Example Application from HSIP-Cycle 5 and HR3-Cycle 3

04-El Cerrito-1

APPLICATION FOR HIGHWAY SAFETY IMPROVEMENT PROGRAM (HSIP) PROGRAM CYCLE 5 AND HIGH RISK RURAL ROADS (HR3) PROGRAM CYCLE 3

Application ID: 04-El Cerrito-1

Exhibit 3
Collision Diagram

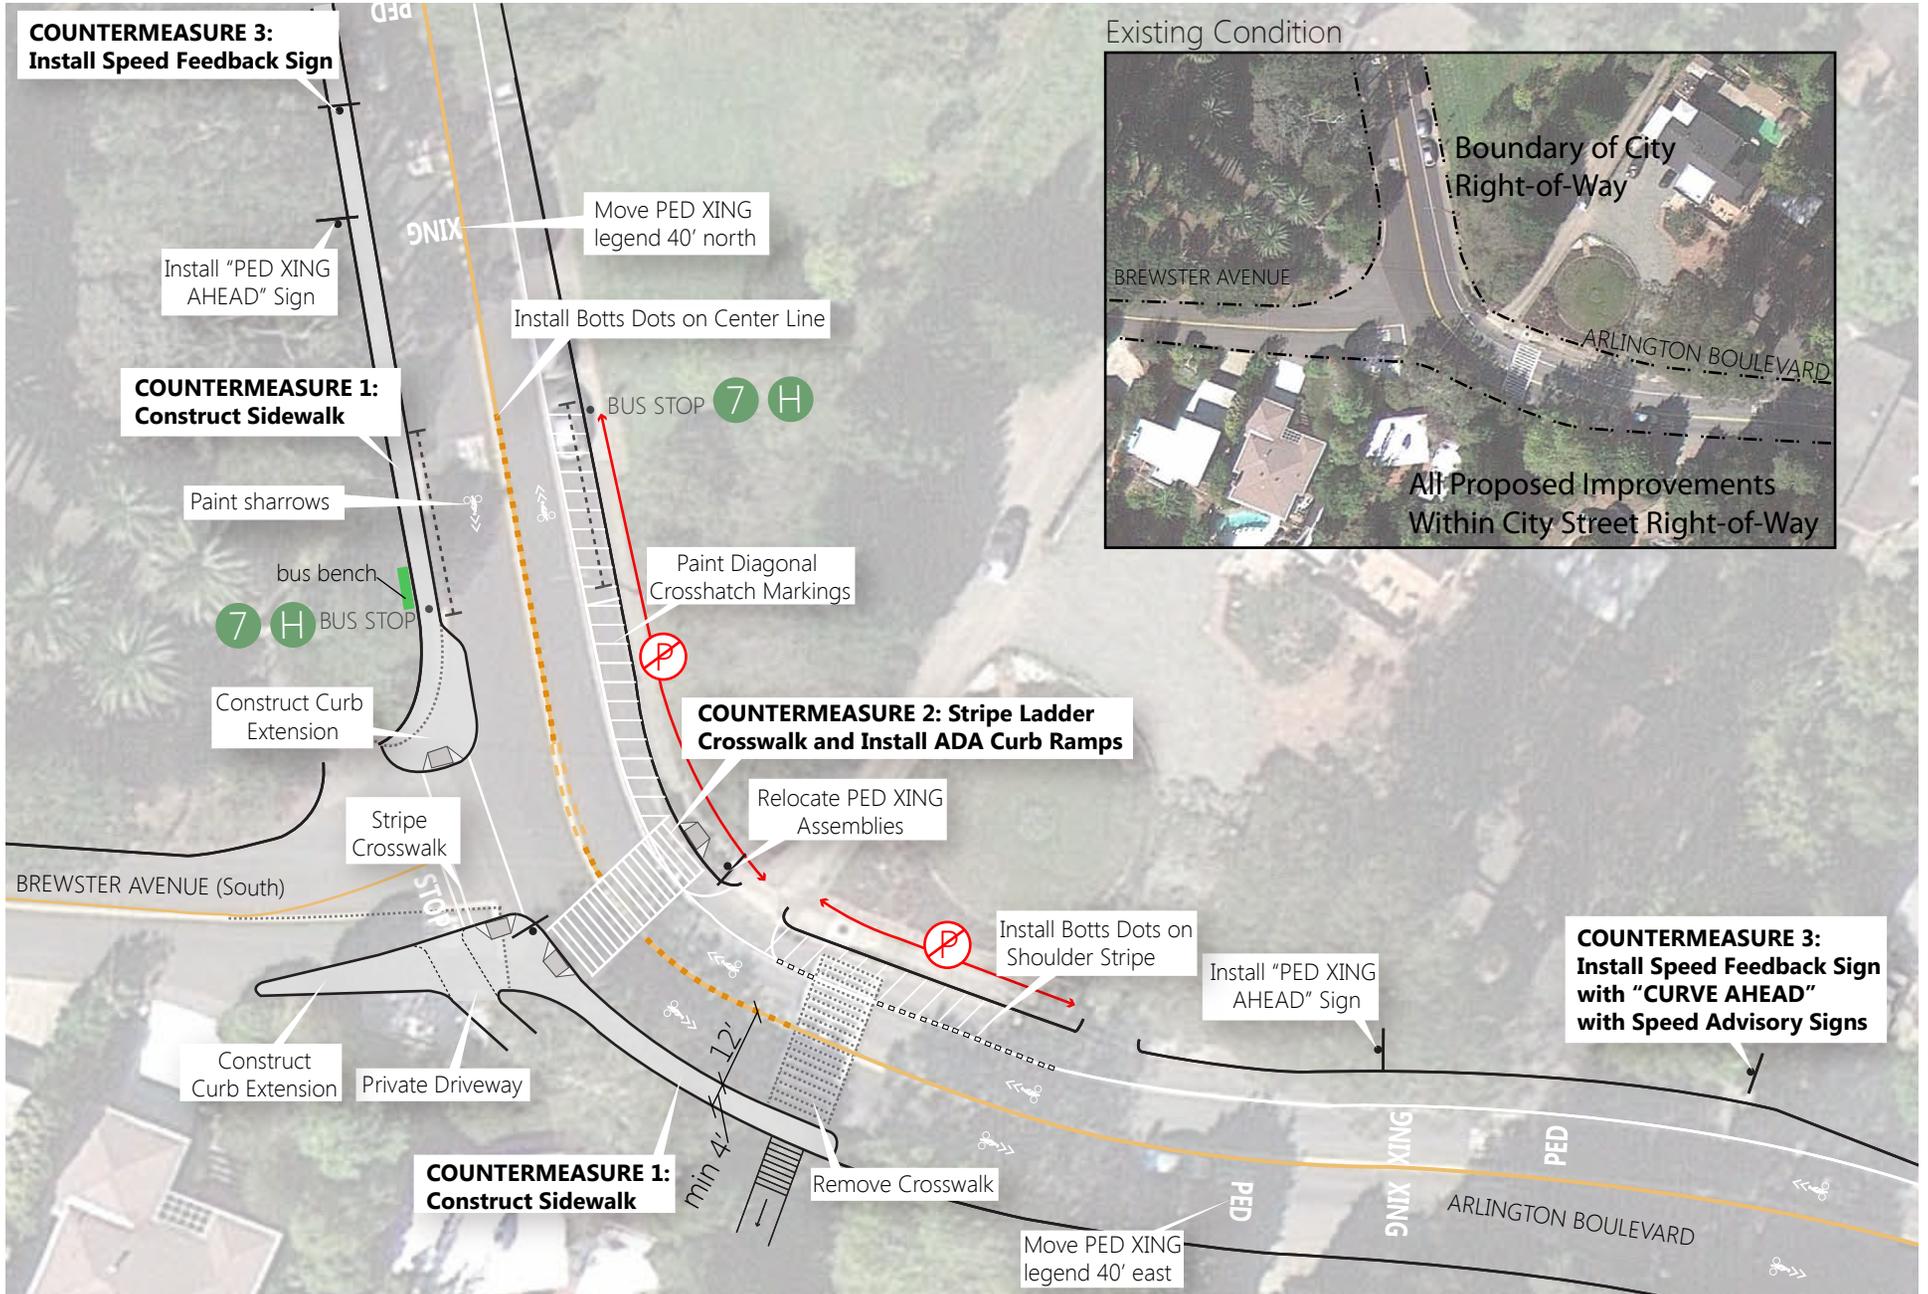
- Applicant clearly explained the logic behind each countermeasure in the narrative questions
- Collision diagram illustrated individual movements/impacts of each collision. This is not a requirement for HSIP/HR3 applications, but can be very useful for agencies as they select their proposed countermeasures
